Errata

Date: 10/17/2018

Name of Document: Advanced Methodology to Assess Riprap Rock Stability at
Bridge Piers and Abutments

FHWA Publication No.: FHWA-HRT-17-054

Source: Modified by FHWA from NCHRP report 568. See Acknowledgment page. *
Figure 1. Graph. Comparison of riprap sizing curves at a rectangular pier.

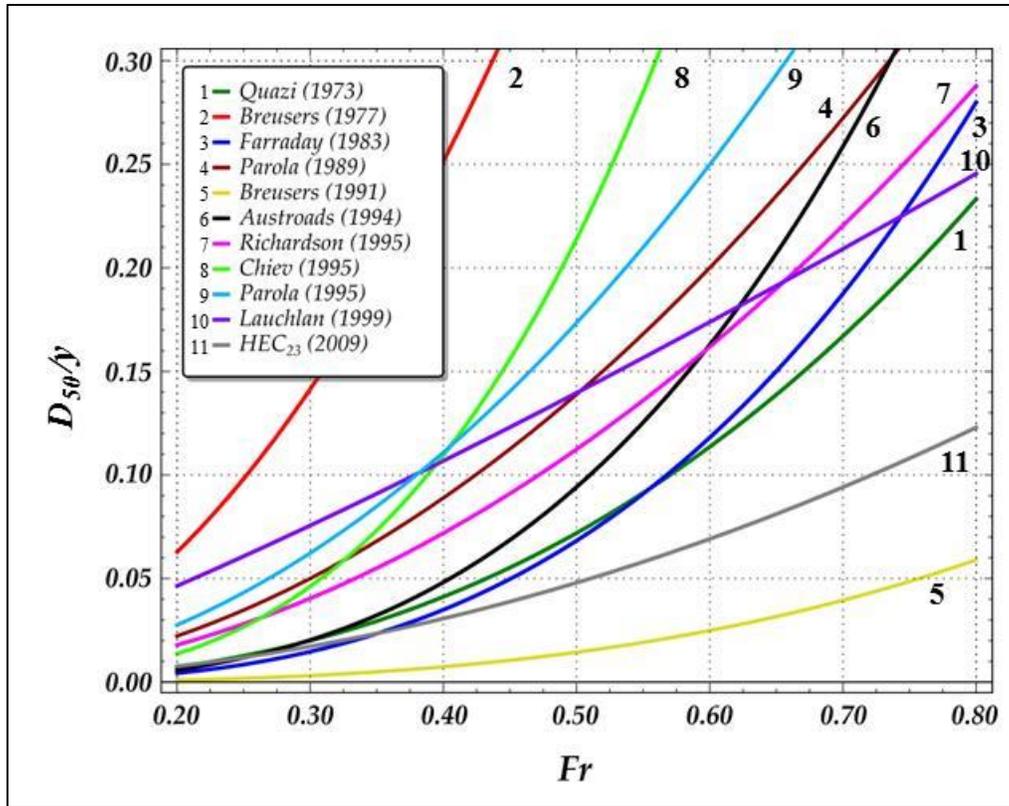
Location	Incorrect Values	Corrected Values
Page 2 Editorial Correction	Source information for Figure 1 missing.	Added source information, Source: Modified by FHWA from NCHRP report 568. See Acknowledgment page.
Page 10 Editorial Correction	In addition, rocks around the upstream corner of first the abutment were colored...	In addition, rocks around the upstream corner of the first abutment were colored...
Page 88 Editorial Correction	No reference 43.	Added reference 43. Lauchlan, C.S. (1999). Pier Scour Countermeasures, Ph.D. Thesis, University of Auckland, Auckland, NZ.
Page 89 Editorial Correction	No Acknowledgment page.	Added Acknowledgment page. Figure 1 was modified by FHWA from figure 2.5 of NCHRP report 568, which in turn was modified from an original graph in C.S. Lauchlan's thesis, "Pier Scour Countermeasures." ⁴³
